TECHNICAL SERVICE BULLETIN

SF – 090 Rev.2

DATE: **Month xx, 2022**
TO: All Service and Parts Managers
SUBJECT: Field modifications required for certain evaporator coil drain pans paired with condensing furnaces in upflow applications

*Please see Revision 2 updates, which are noted as *****UPDATE***** in applicable sections below.*

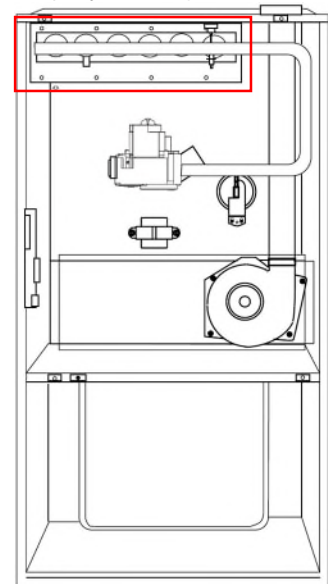
UPDATE

- a. ONLY applies to heat exchanger configurations where burner input is located **at the bottom**. If burner input is located at the top of the heat exchanger (as shown in picture to the right) the furnace is **not exempt** and will require further action.
3. A metal reinforcement is observed below the drain pan of the coil. This indicates modifications have already been performed on the specific coil.
4. The matched furnace is a Daikin, Goodman, or Amana® brand Ultra Low NOx gas furnace.
5. The matched furnace is a Daikin, Goodman, or Amana brand condensing furnace with a constant volume (variable speed ECM) from the model number families listed below in **Table 2**.
6. The matched furnace has a Blower Guard Kit. This indicates that modifications have already been performed on the specific system.

There may be a limited number of non-condensing furnace models from other brands in which the burner input is at the top of the heat exchanger, as shown in the example image on page 2. If you encounter a furnace which fires at the top in an upflow configuration, it should be treated as in scope for the recall, and the DPKT should be installed according to table 4.
